Ordinance No. 018020

rezoning property located on the northwest corner of Silvey Street and West Worley Street, extended, from District R-1 to District PUD-6; approving the PUD site plan of The Villas at Vintage Falls; granting variances from the Subdivision Regulations; and fixing the time when this ordinance shall become effective.

AGENDA REPORT
PLANNING AND ZONING COMMISSION MEETING - FEBRUARY 19, 2004

ITEM NO. 11-PUD-03

THE VILLAS AT VINTAGE FALLS

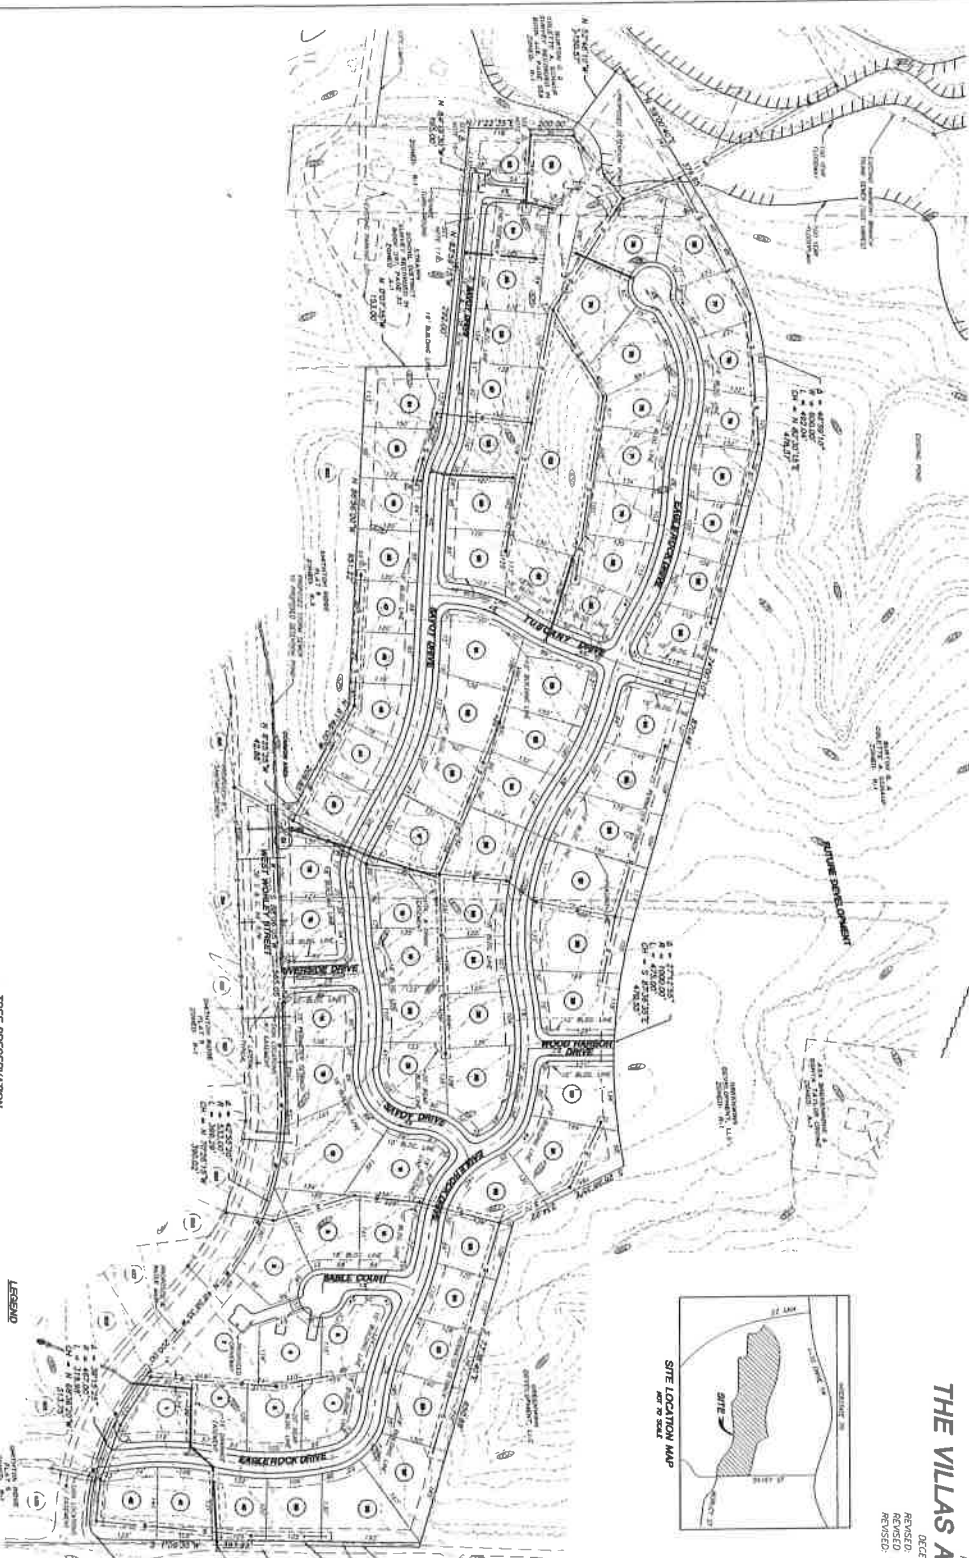
The first variance request is to the requirement that the internal, local residential streets be 32 feet in width (except for cul-de-sacs, which are currently allowed to be 28 feet wide). The PUD proposes that all streets, except for Savoy Drive, be 28 feet in width, within the standard 50-foot wide right-of-way. Twenty eight feet of pavement width within a 50-foot right-of-way is the new standard being proposed as part of the revised street standards; however, this revised standard is for single-family and not two-family residential development. Unless the applicant can provide some compelling reason why the streets should be less than 32 feet in width for a two-family development, staff cannot support this variance request.

The second variance request is to allow a proposed 24-foot pavement width within a 38-foot wide right-of-way for the west 400 feet (serving Lots 52-56) of Savoy Drive. The Savoy Drive right-of-way is being placed 10 feet north of the Strawn School property to allow room for a 10-foot wide utility easement on the subject site. Staff is not opposed to this "spite strip," in this case, since the applicant needs to provide room for a utility easement and the Strawn School property takes its access off Strawn Road and does not need to connect to the subject site.

The proposal is to prohibit parking on both sides of Savoy Drive, which has been recommended by the Public Works Department as a condition of having the 24-foot wide street. The proposed street standards include an "Access Street," which is somewhat similar to what is being proposed, but differs as follows: 1) "Access" streets are intended only for single family homes (duplexes are being proposed here); 2) parking is allowed on one side (no parking is proposed on Savoy Drive); and, 3) "Access" streets require a 44-foot wide right-of-way (Savoy Drive would have 38 feet of right of way). The 38 foot right of way is of less concern in this case since no sidewalk is proposed on the south side and a 4 foot buffer would exist. Planning staff questions the viability of not allowing any parking since no common off-street parking is being provided. If parking is prohibited and driveways fill up, visitors may park on the street anyway. How will the prohibition on parking be enforced? If a 7-foot wide parking area was allowed on the south side, a 17-foot travel way would remain. This is more than the 14 feet available on 28-foot wide residential cul-de-sac street with parking on both sides, which is allowed under the current Subdivision Regulations.

The third variance request is to allow a "t" type turn-around at the terminus of Savoy Drive, in lieu of the standard cul-de-sac bulb of 94 feet of right of way and 76 feet of pavement. The proposed "Access" street would require a cul-de-sac bulb but with a reduced diameter of 84 feet of right of way and 68 feet of pavement. The "T" would be adequate for cars and light trucks but may present a problem for large vehicles such as trash trucks. The Public Works Department has identified operational problems with the "t" turn around. It may act as a vehicle storage area, which would block street sweepers and refuse vehicles. It could also create a problem with accumulated debris, if the street sweeper cannot adequately clean the turn around area. Staff is also concerned that this will set a precedent for future PUDs. In other words, if this is approved, it may become "the new standard" for cul-de-sac design on future PUDs.

The fourth variance request is to allow for Savoy Drive, a cul-de-sac street, to be 780 feet in length, in lieu of the 750-foot maximum length allowed. Since the cul-de-sac will serve only 26 dwelling units (13 lots), the 30-feet of additional length is of little concern.

The fifth variance is to construct a sidewalk only on the north side of the west part of Savoy Drive (along Lots 52 through 56). Since there will be no development along the south side, due to the presence of the Strawn School site, the variance is justified.

The 28-foot wide streets, the lack of parking for Savoy Drive and "t" type turn around variances are problematic to staff. In addition to the street issues, staff is of the opinion that the 18-foot front setback proposed for the residential dwellings is too shallow and should be increased to 20 feet. This is due to the fact that some vehicles, such as trucks, vans and large SUVs are over 17 feet in length and, when parked in a driveway in front of the garage, they will extend out over the sidewalk if the setback is only 18 feet. Drivers cannot be expected to park their car with the bumper right up to the garage door.

Staff would recommend approval of a revised PUD site plan, which eliminates the above problems. Staff suggests that the site plan be tabled to March 4, 2004, to allow time for revisions to be made. If the applicant is unwilling to revise the plan, staff recommends denial.

1. That a payment of \$14,742 toward future improvements to Silvey Street be paid prior to final plat approval
2. That the plan be revised to allow for parking on one side of Savoy Drive.
3. That at the time of final plat submittal, the final plat shall show a greenspace trail easement along the Harmony Creek 100-year flood plain; and, that the final plat show a minimum 10-foot wide pedestrian easement, connecting at least one of the public streets within the development to the greenspace trail easement.
